DANE COUNTY DEPARTMENT of PUBLIC WORKS, HIGHWAY and TRANSPORTATION

RFB NO. 313083 - ADDENDUM NO. 3

CONSTRUCTION OF EAST HIGHWAY GARAGE – SALT STORAGE FACILITY (BID PACKAGE A) AND MEDICAL EXAMINER OFFICE BUILDING (BID PACKAGE B)

**DEPARTMENT OF PUBLIC WORKS,
HIGHWAY & TRANSPORTATION
3562 COUNTY HIGHWAY AB
MCFARLAND, WISCONSIN**

3 PARTIAL ENLARGED MECHANICAL ROOM - HVAC - ALTERNATE B2
SCALE: 1/4"=1'-0"

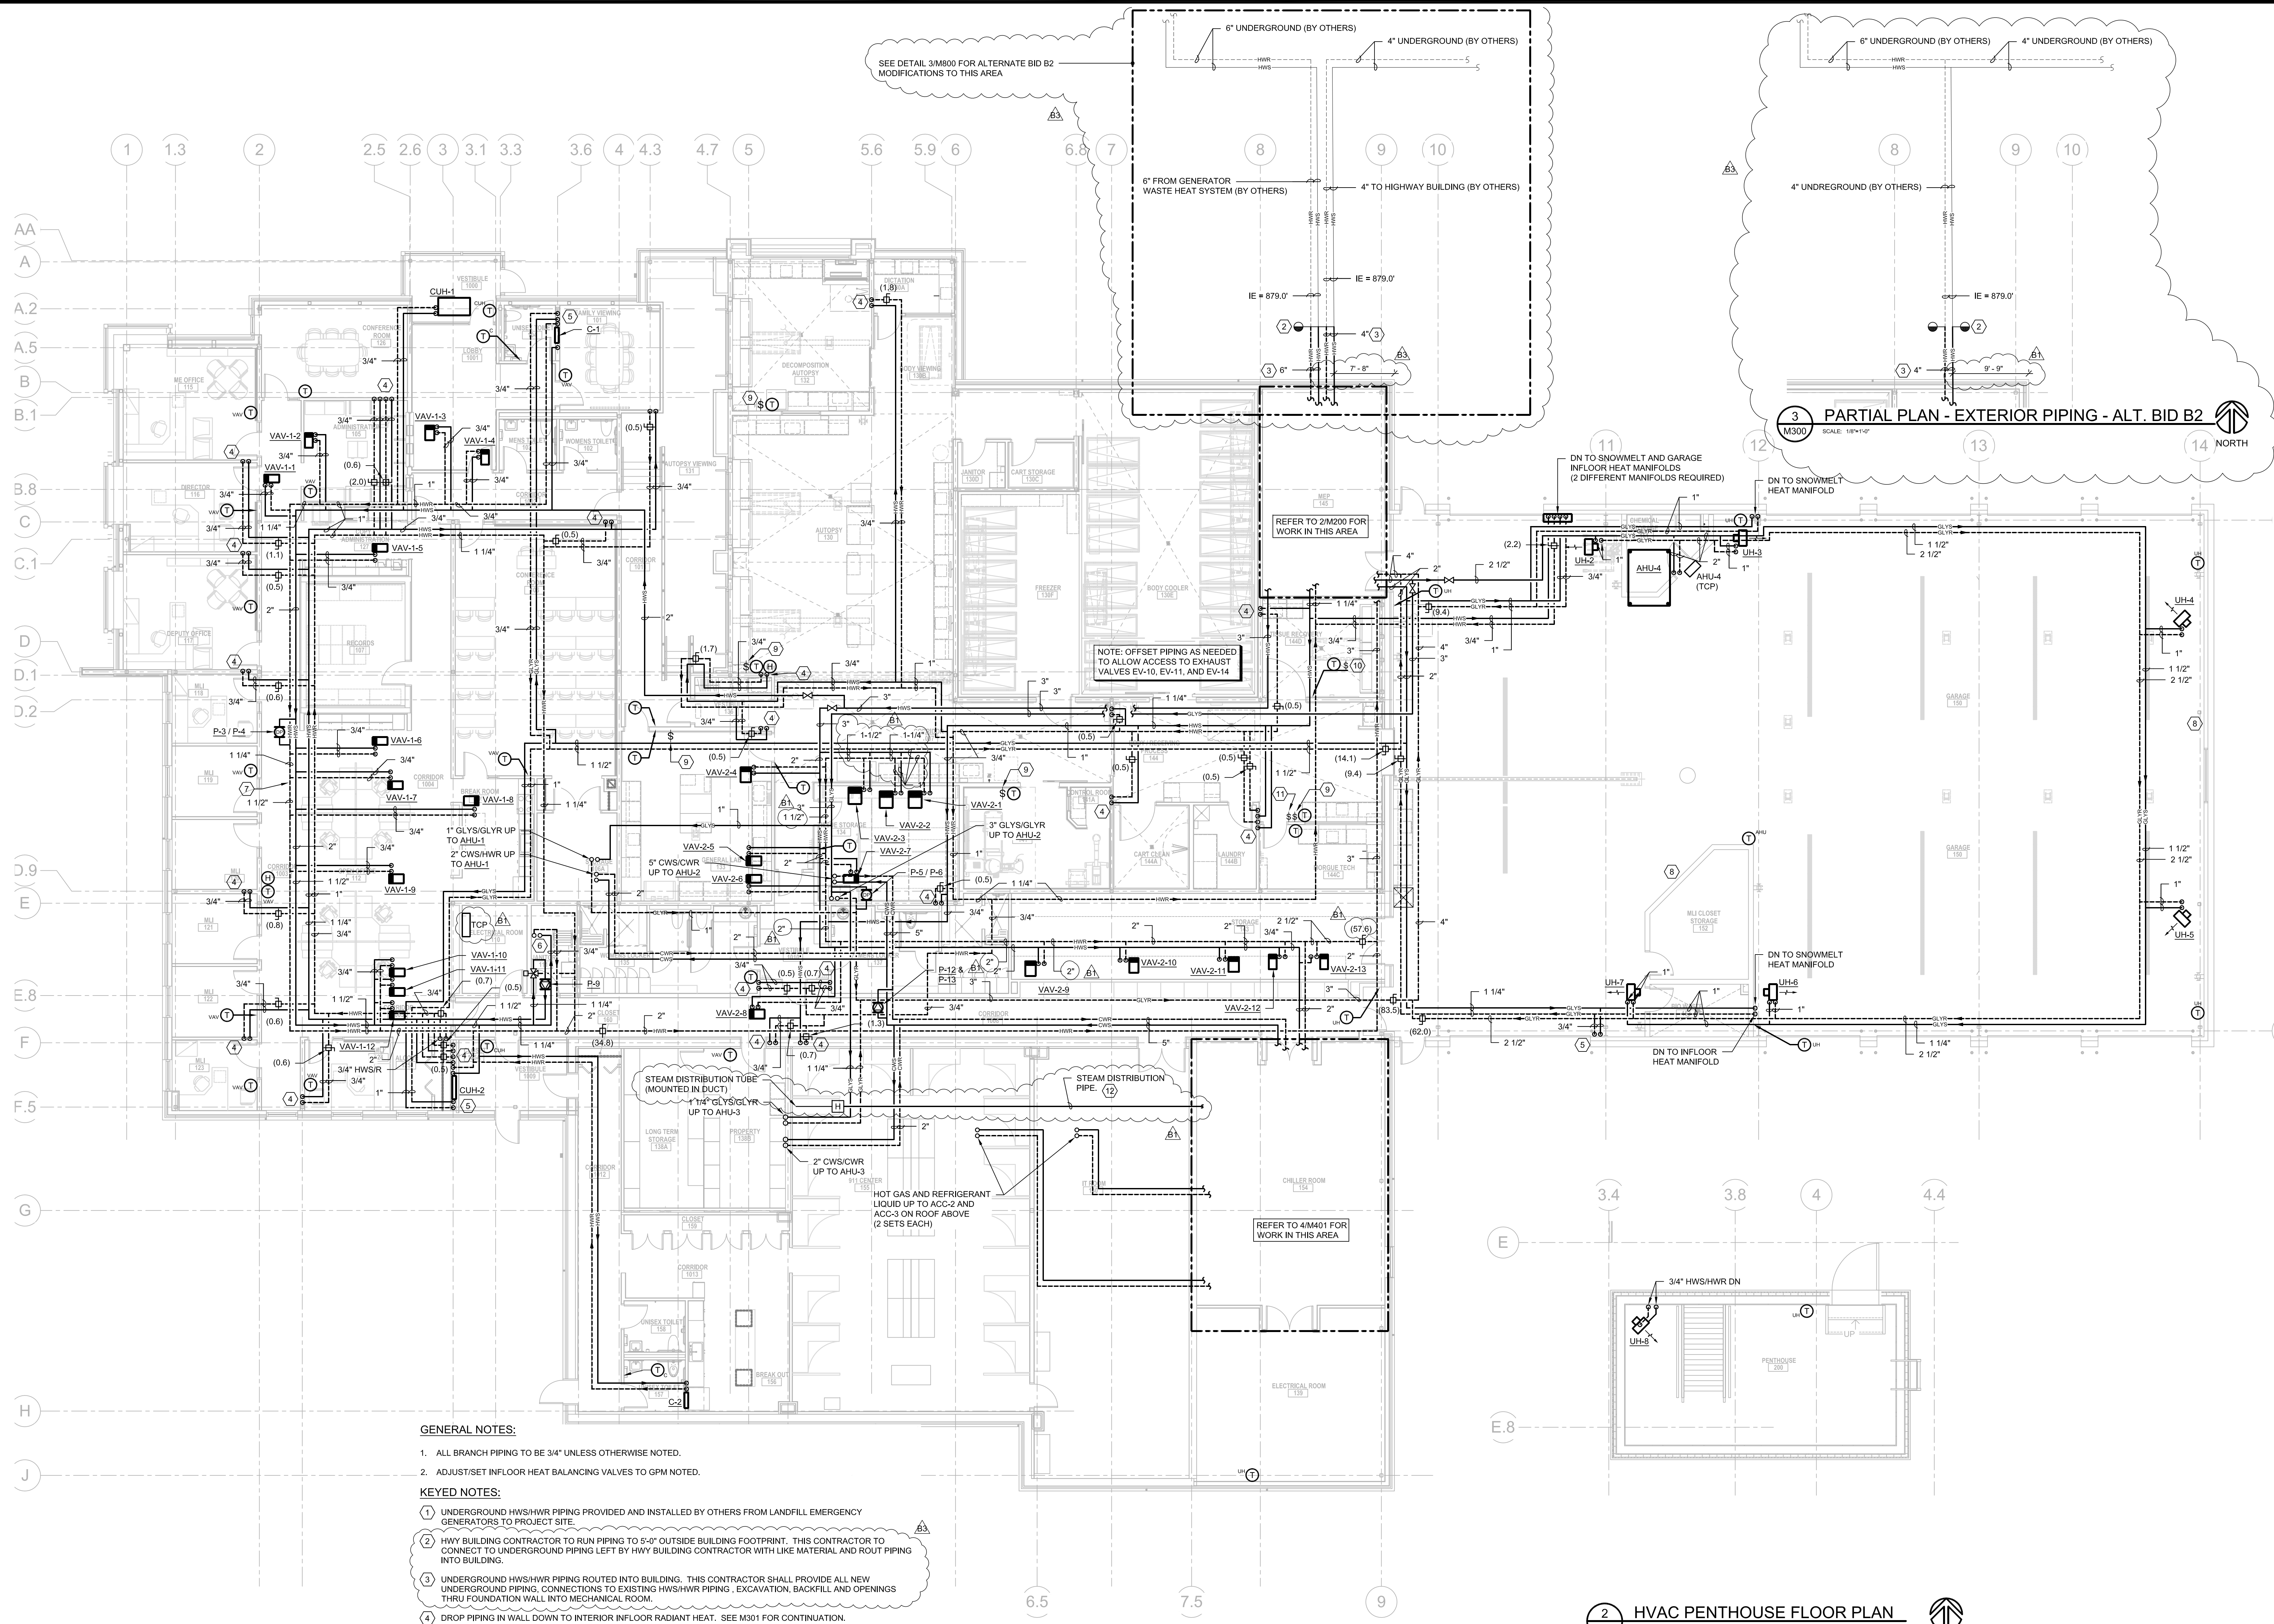
26. P200
 - a. Add garbage disposal (GD-1) at sink (S-1) in Break Room 109 and sink (S-1) in Break Out 156.
27. M200
 - a. Replace in it entirety.
 - b. Detail 1/M200 modified.

- c. Detail 2/M200 modified.
 - d. Detail 3/M200 added.
28. M300
 - a. Replace in it entirety.
 - b. Detail 1/M300 modified.
 - c. Detail 3/M300 added.
29. M800
